SUBJECT: COMANCHE PEAK STEAM ELECTRIC STATION (CPSES)
DOCKET NO. FJ-446
ADVANCE FSAR SUBMITTAL - UNIT 2 UPDATE FOR OPTIMIZED
FUEL ASSEMBLY AND UNIT 2 ACCIDENT ANALYSES METHODOLOGIES

1. A marked-up copy of the revised FSAR pages (changes are indicated in the margin by the word "draft").
2. A description/justification of each change.

FIGURE 15.0-2B

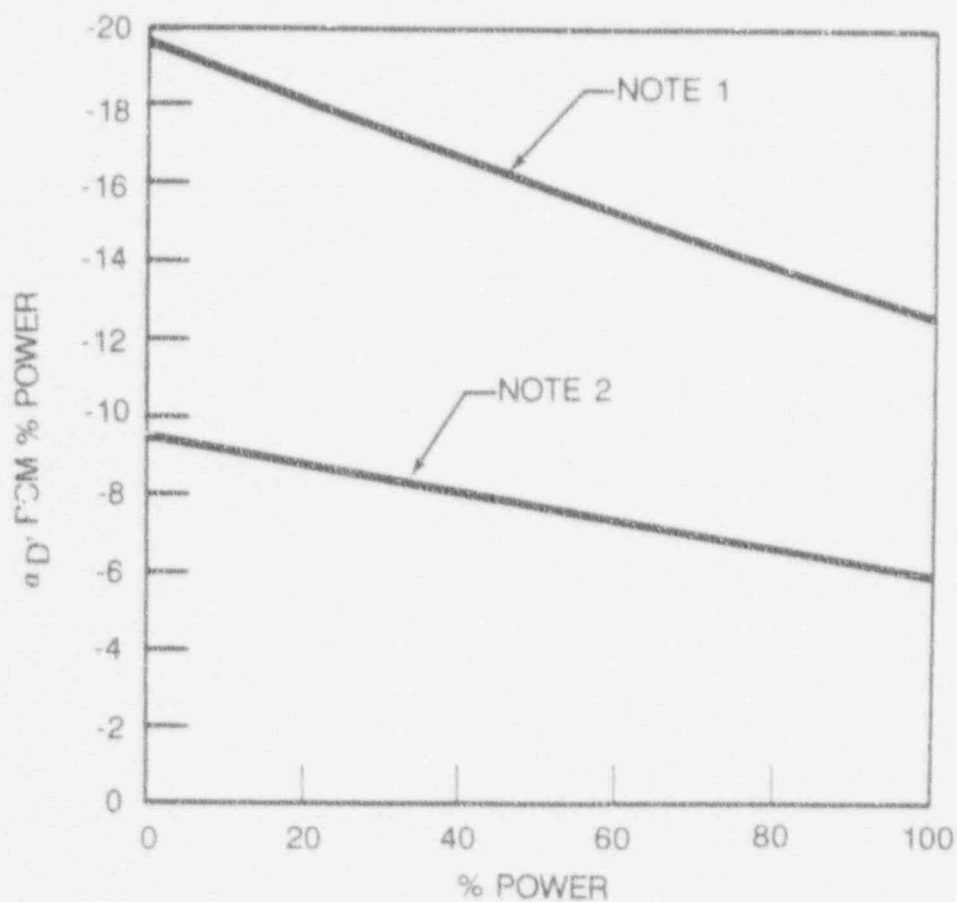
In Amendment 84, Figure 15.0-2B was inserted for the doppler coefficients used in the Unit analyses. The Figure inadvertently inverted the upper and lower doppler curves. A new Figure 15.0-2B has been provided.

FIGURE 15.6-6

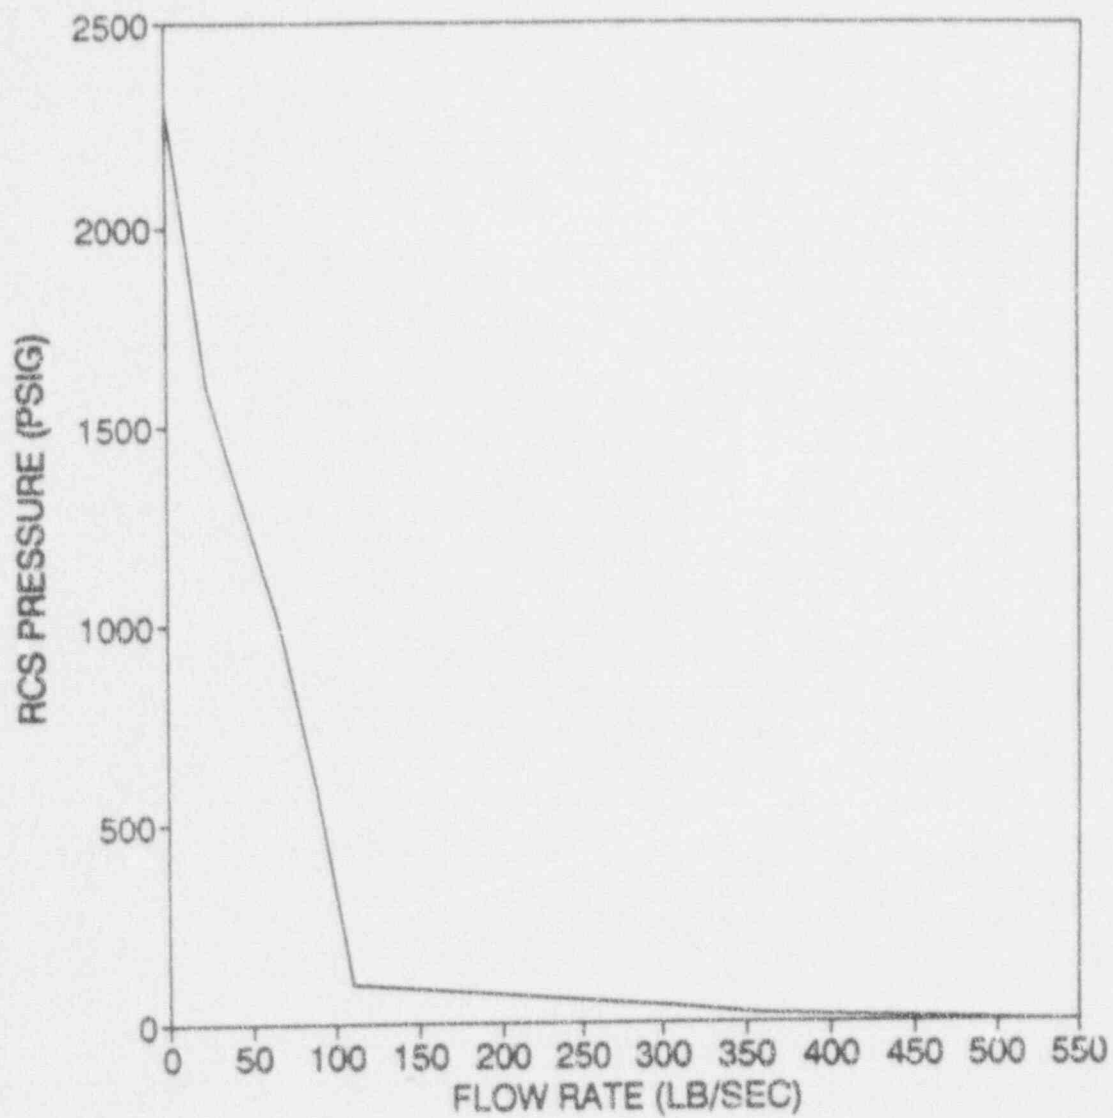
The Unit 2 Small Break LOCA analysis uses the NOTRUMP code. Figure 15.6-6 has been changed to reflect this difference from Unit 1.

Figure 15.6-47A

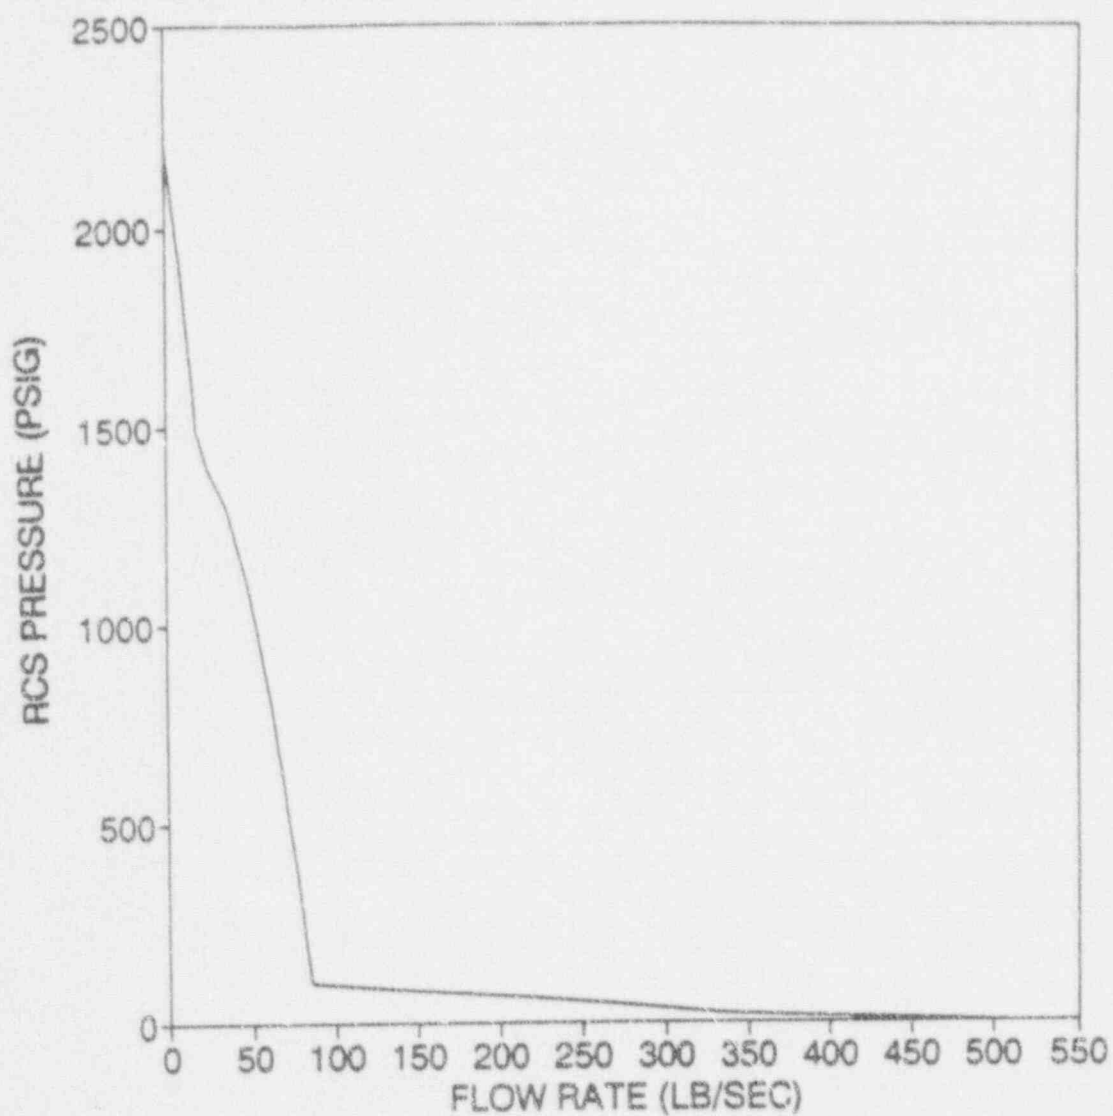
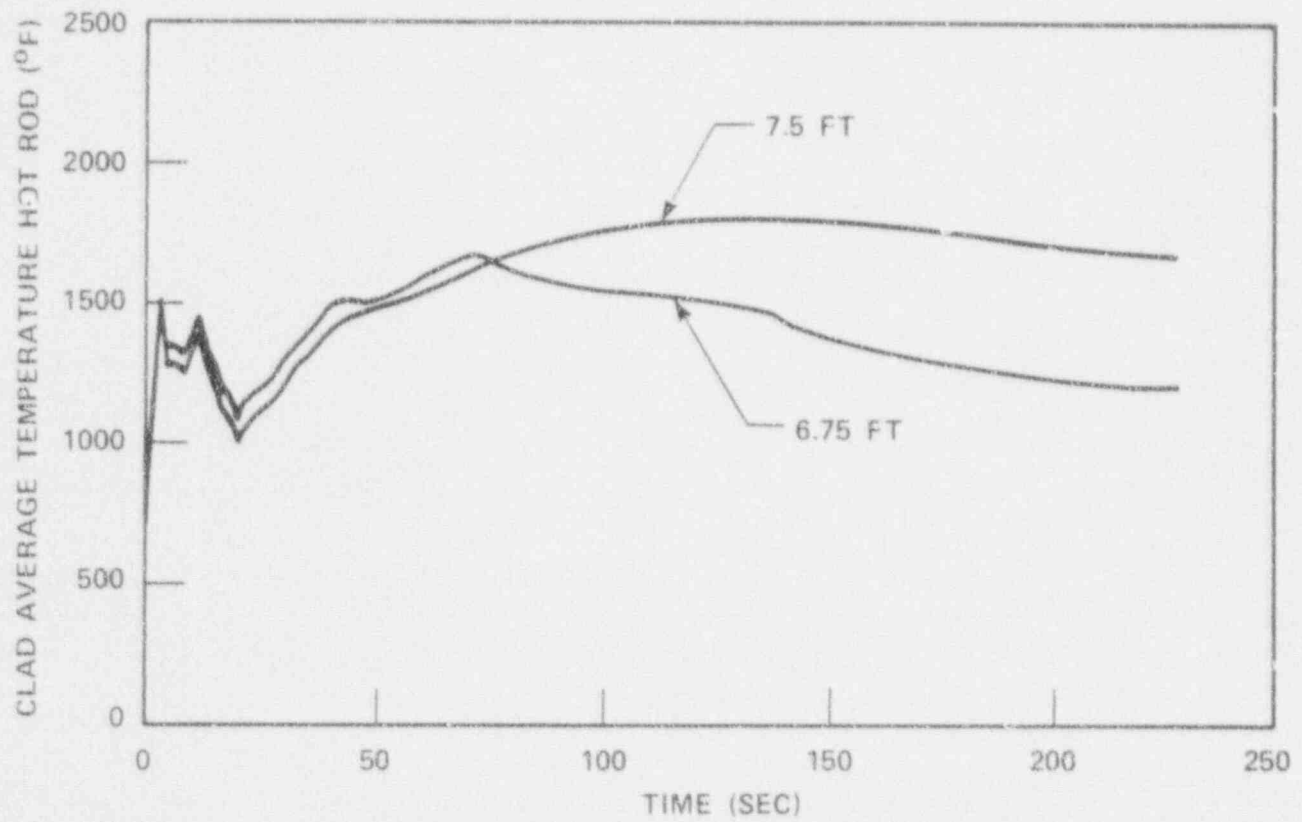
The Safety Injection Flow Rate Figures for the Large and Small Break LOCAs have been updated to account for plant changes to the Residual Heat Removal system.
